Date: August 11, 2015
To: Rogelio Lozada WP – Commissioning Mgr.
Luis Ramirez WP - Sr. Process Engineer
From: Javier Rios UOP Tech Service Specialist
CC: Distribution
Customer: EP PetroEcuador – Esmeraldas, Ecuador
Subject: **UOP-EPP-FCC PROC-024- Hot Spot recommendations for fixes and proposed path forward for 8-5-2015 inspection**

Refractory repair – Level 4

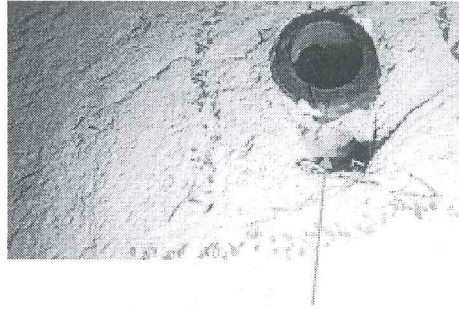
Repair for refractory after checking with specialist the plate coverage will not cover the section and be effective towards removal. Due to that reason we removed on new units the ring coverage for a few items. The repair must be done as per recommended UOP specification 3-22-7.

Spent catalyst Stand pipe – Level 5

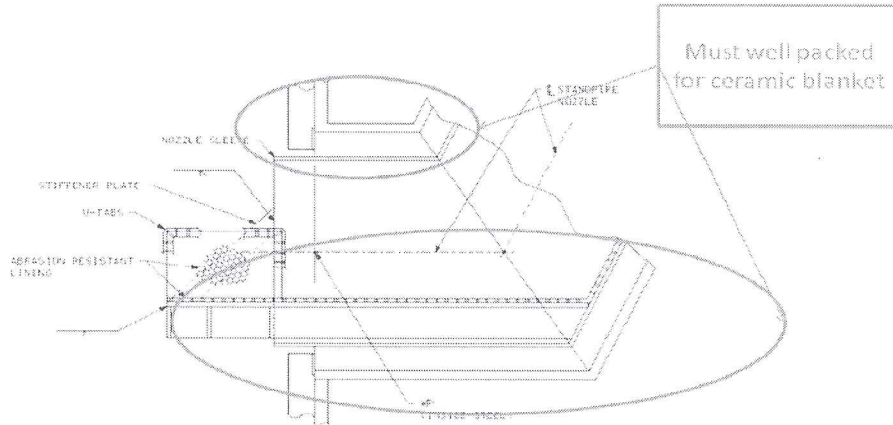
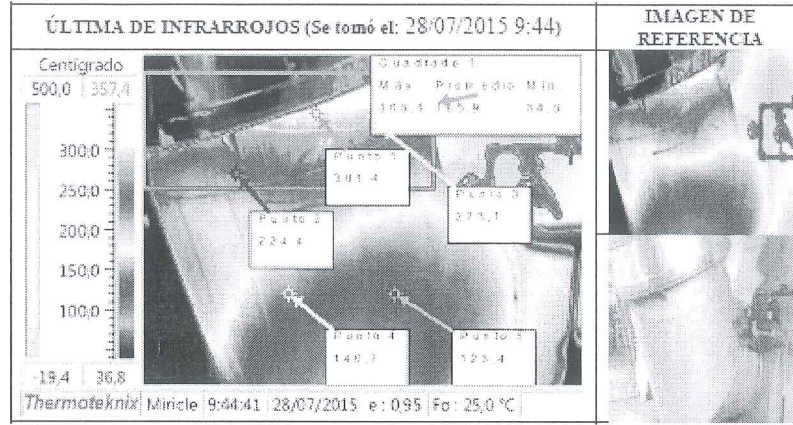
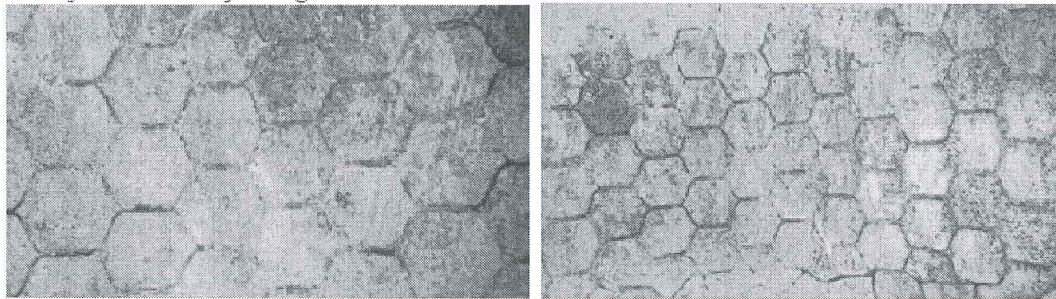
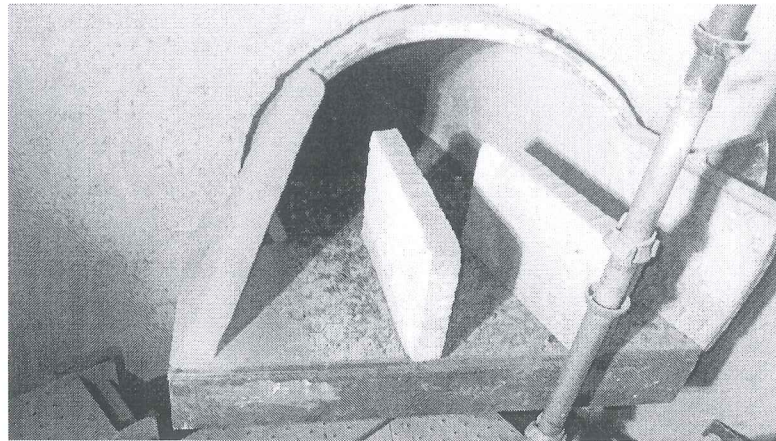
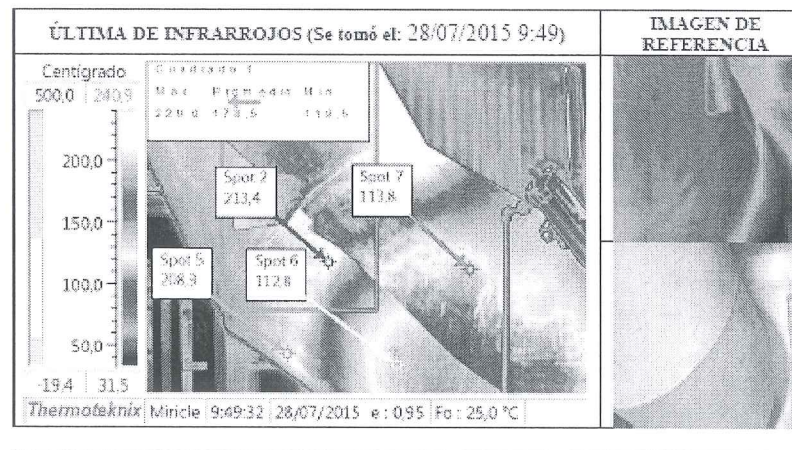
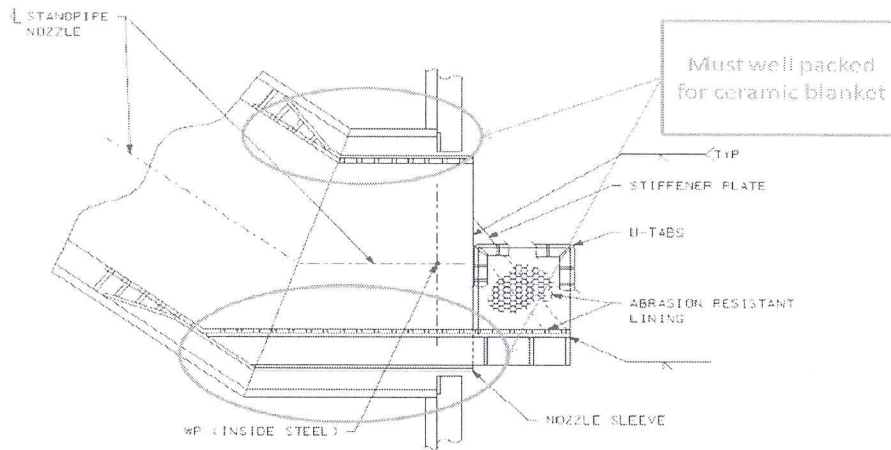
The hot spot was located and inspected for refractory.

After careful review UOP understands that the potential main root cause for the stand pipe is that the ceramic packing was not incorrectly placed. This created a hot spot in the upper part due to air concentration and not able to isolate the system. The problem most likely might be internal due to the already added packing to the system outside:

Unfortunately to fix this item the refractory and the ring must be removed to ensure that repacking the ceramic blanket to ensure the section is properly. Please note that the main reason is due to the internal ceramic that must have had cover the section. If the section of the ring is not removed then the bended section is hard to remove the packing and ensure it will work correctly.

5 Re-circulation Stand pipe

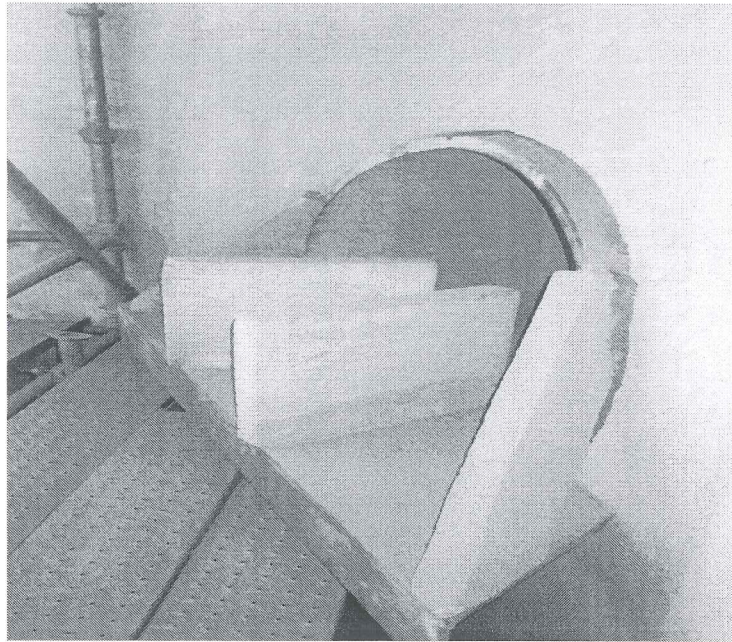
The hot spot was located and inspected for refractory.

After careful review UOP understands that the potential main root cause for the stand pipe is that the ceramic packing was not incorrectly placed. This created a hot spot in the upper part due to air concentration and not able to isolate the system. The problem most likely might be internal due to the already added packing to the system outside.

Unfortunately to fix this item the refractory and the ring must be removed to ensure that repacking the ceramic blanket to ensure the section is properly. Please note that the main reason is due to the internal ceramic that must have had cover the section. If the section of the ring is not removed then the bended section is hard to remove the packing and ensure it will work correctly.

Catalyst Cooler Stand pipe – Level 4

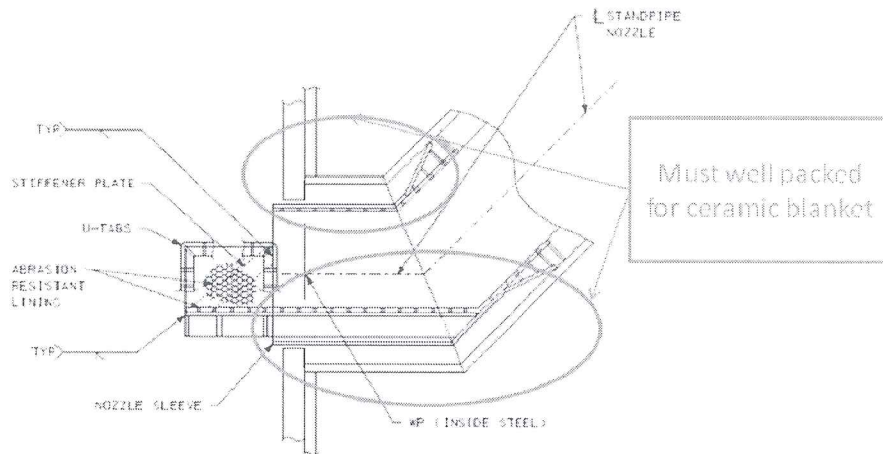
This item is recommended to be checked since we don't have an IR and as per findings on the other stand pipes it seems that they were not properly installed. This can be confirmed on the findings for the other stand pipes packing for the upper section.
